Subject: Response to Letter Dated February 17, 1994

Reference: Docket 71-9019

This responds to your letter dated February 17, 1994, which requested additional information regarding GE's Consolidated Application dated December 3, 1993, seeking a revision to Certificate of Compliance USA/9019/AF for the Model No. BU-7 shipping container.

ATTACHMENT 1

FIGURE 10A SUBMITTED 3/18/94

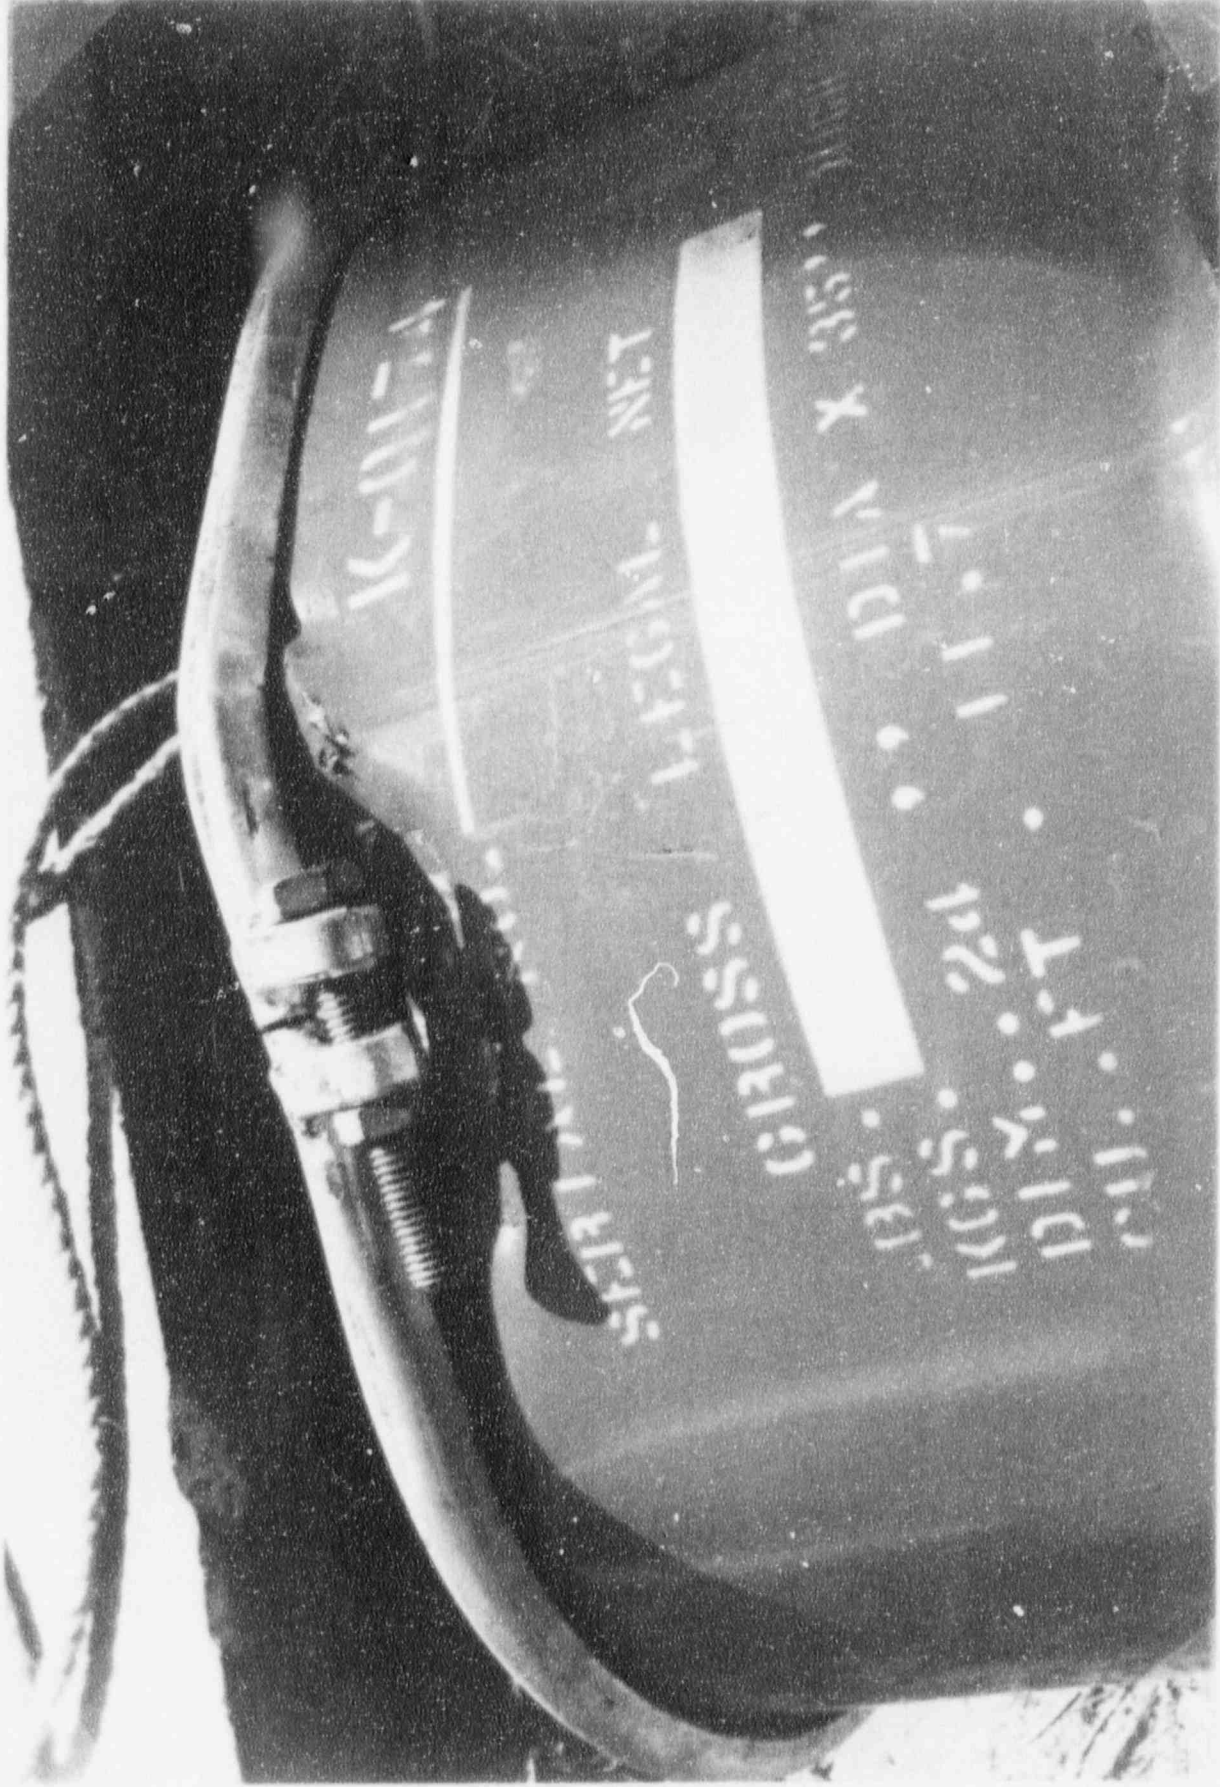
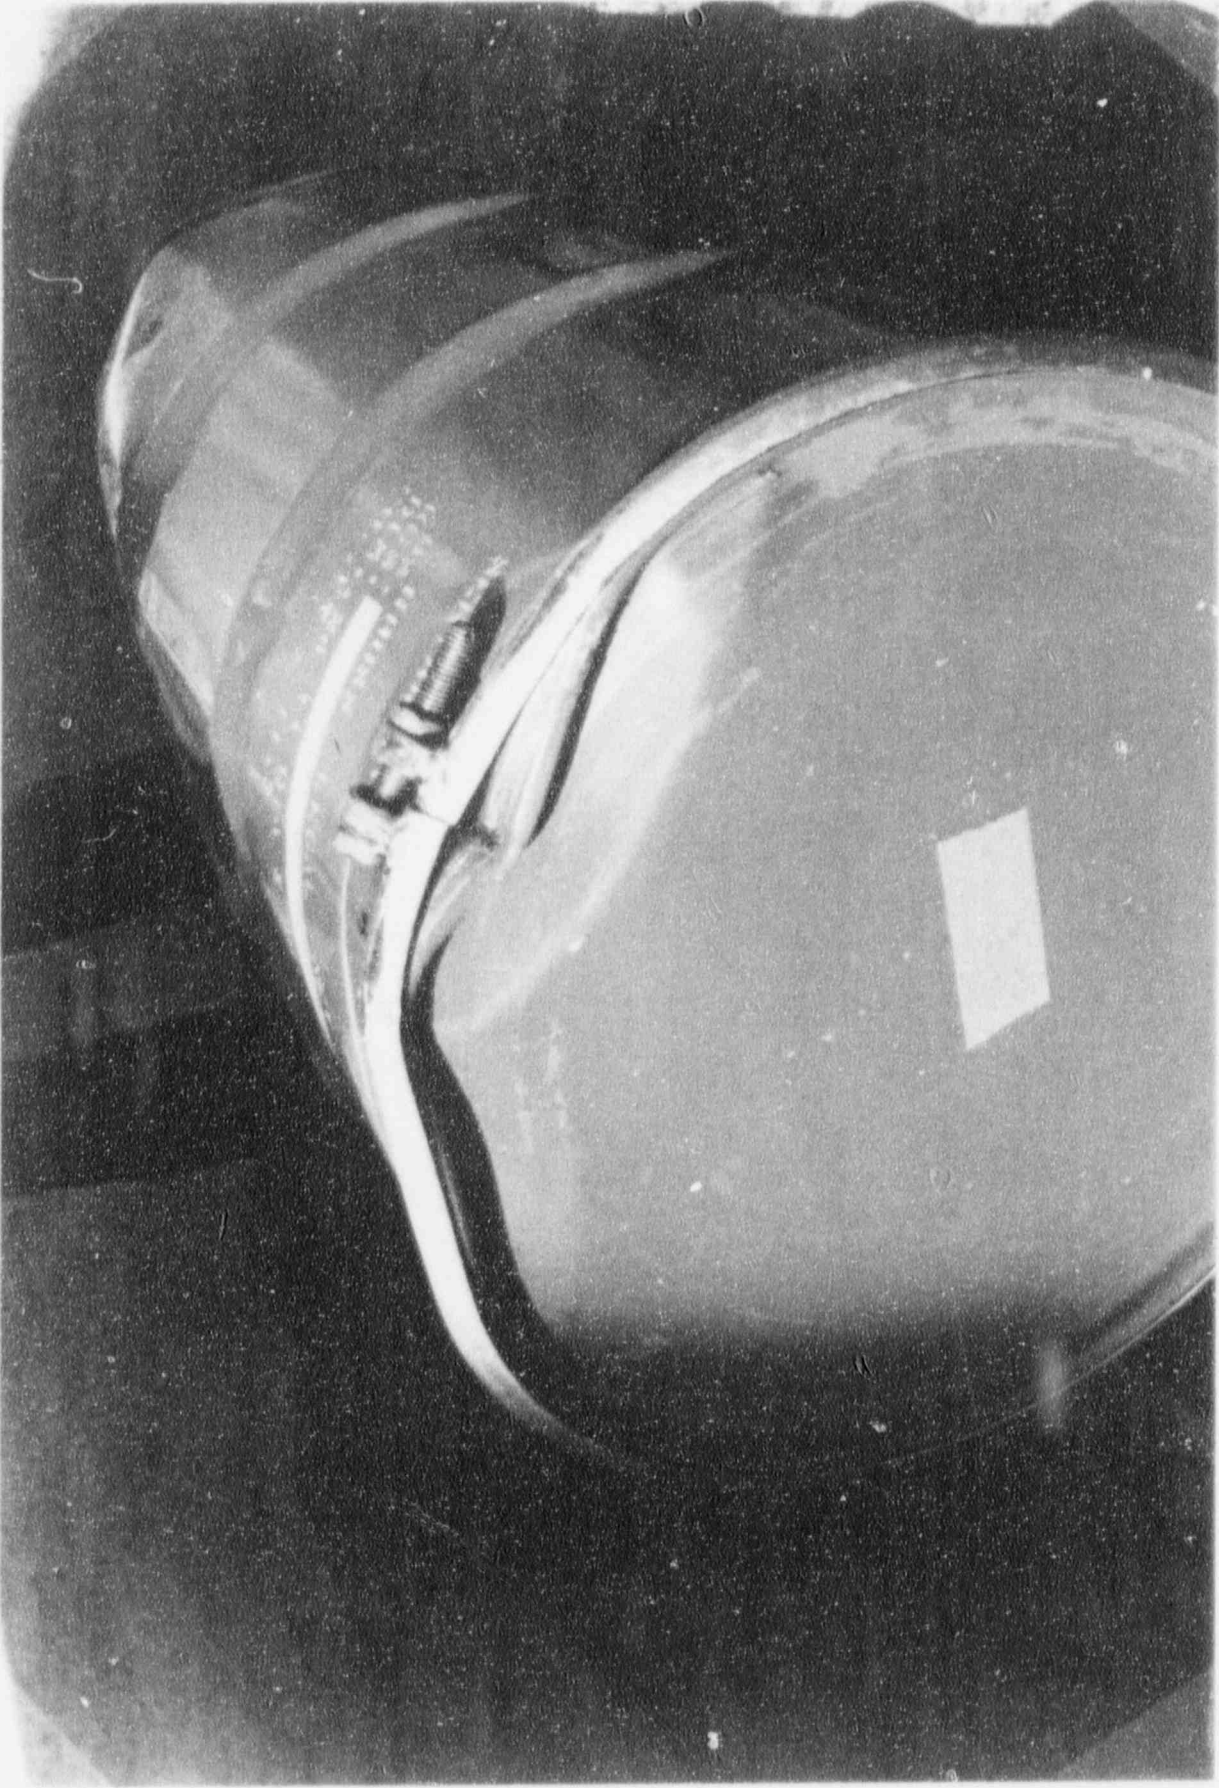
4. Figure No. 10 in Appendix B of the application is incorrectly labelled. It does not appear that this is a photograph of drum No. K-1878 (see, for example, Figure No. 11 in the same appendix). In Figure No. 10, the bolt which secures the drum locking ring appears to be broken. Provide a description of the damage sustained by this bolt. If possible, provide an additional photograph which clearly shows that the bolt did not break due to the 30-foot drop test.

Figure 10 shows no breakage or damage to the closure bolt and the test engineer interviewed recalls none. The darkened area in question is a shadow as can be seen from the lighting in the photograph (cf the point of the closure ring at the nut location). In support of this position, GE has located two additional photographs from the photo sequence of the bolt on container K-0174 which more clearly show from two different perspectives that the bolt is not damaged. The photographs are enclosed and are being incorporated into the test report (Figures 10A and 10B) to avoid the ambiguity generated by Figure 10.

2. Figures 10A and 10B have been added. These are photos of BU-7 serial number K-0174 that have not been provided to the NRC in the past. They show that the bolt securing the outer ring was not broken. These two new figures are also identified with the drum serial number and the date of this transmittal.
